Access Compliance Report

Public Rights-of-Way

(Curb Ramps)

Intersection ID: 49705	Main Street: LOUGHLIN_LN	Cross Street: VAUGHAN_DR	Location: NE
ADA ID: E8FC7FA7393C	Ramp Type: PerpDiag	Initial Pass/Fail: Fail	Overall Compliance: No
Severity Score: 22.5			
Codes/Mitigation Info/Possible Solution		Field Measurements/Component Compliance

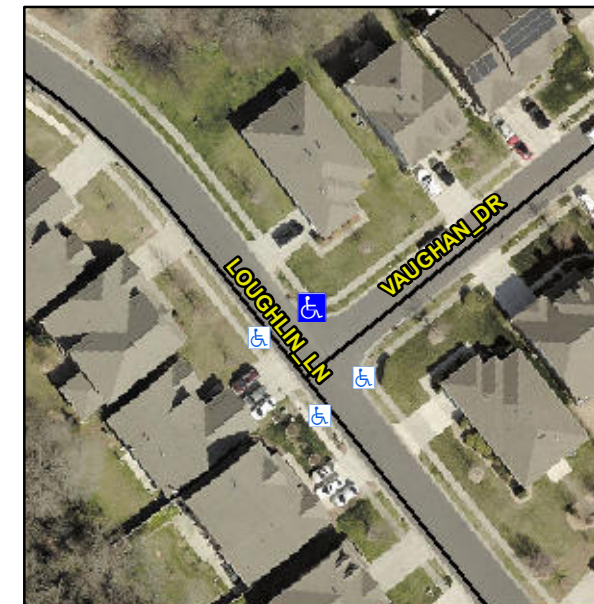
Not Found, R304.5.1, R304.2.2, R304.5.3

Compliance	Description	Data	Compliance	Description	Data
N/A	Ramp Length (in)	47.0	No	Ramp Slope (%)	10.2
No	Ramp Width (in)	47.5	No	Ramp XSlope (%)	4.4
N/A	Flare Type LT	N/A	N/A	Flare Type RT	N/A
N/A	Flare Slope LT (%)	N/A	N/A	Flare Slope RT (%)	N/A
N/A	Flare Traversable LT?	N/A	N/A	Flare Traversable RT?	N/A
N/A	Landing Length (in)	N/A	N/A	DWS Provided?	N/A
N/A	Landing Width (in)	N/A	N/A	DWS Contrast?	N/A
N/A	Landing Slope (%)	N/A	N/A	DWS Length (in)	N/A
N/A	Landing X Slope (%)	N/A	N/A	DWS Full Width?	N/A
N/A	Landing Curb? (Y/N)	N/A	N/A	DWS Offset (in)	N/A
N/A	Shared Landing?	N/A			
N/A	Gutter Ponding?	N/A	N/A	Gutter Slope (%)	N/A
N/A	Gutter Lip Ht (in)	N/A	N/A	Gutter X Slope (%)	N/A
N/A	Painted X Walk1?	No	N/A	Painted X Walk2?	No
	X Walk 1 Direction	To SW		X Walk 2 Direction	To SE
N/A	X Walk 1 Width (in)	N/A	N/A	X Walk 2 Width (in)	N/A
	X Walk 1 Slope (%)	2.3		X Walk 2 Slope (%)	2.6
	X Walk 1 X Slope (%)	4.1		X Walk 2 X Slope (%)	0.5

Remove & Replace Curb Ramp With Two New Directional Ramps or Equivalent.
